NEW MEXICO OIL CONSERVATION DIVISION

APPLICATION FOR AUTHORIZATION TO INJECT

RE: Application for Authorization to Inject
OCD Form C-108
Order R-4442-G
Vacuum Grayburg San Andres
Lea, County, New Mexico

Water, Gas & CO2 Injection Expansion
Vacuum Grayburg San Andres Unit # 247
Lea County, New Mexico

VGSAU 247 WI WELLBORE DIAGRAM

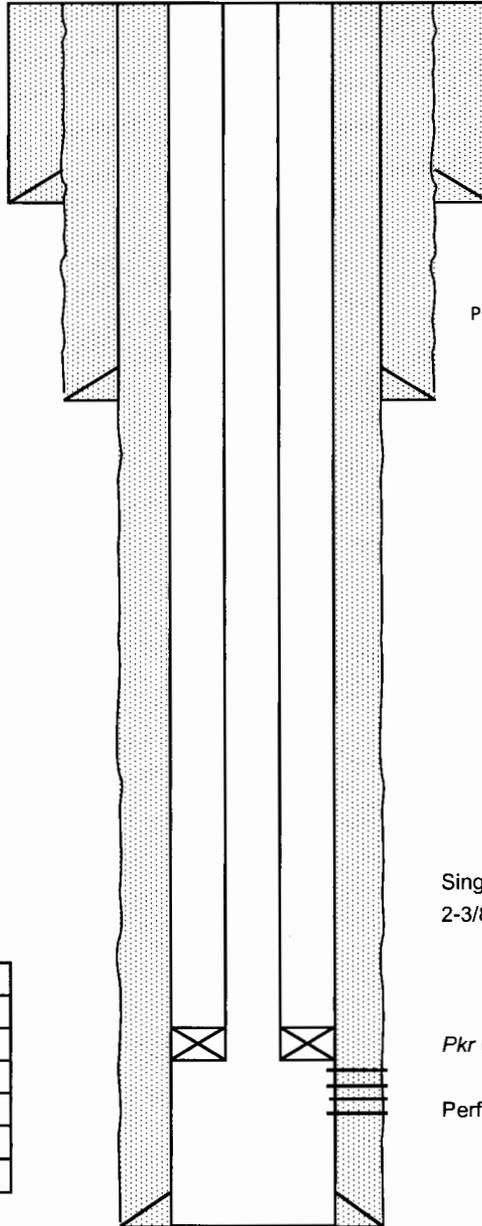
Since you are doing an “S” shaped well, please send a schematic or some drawings of that.
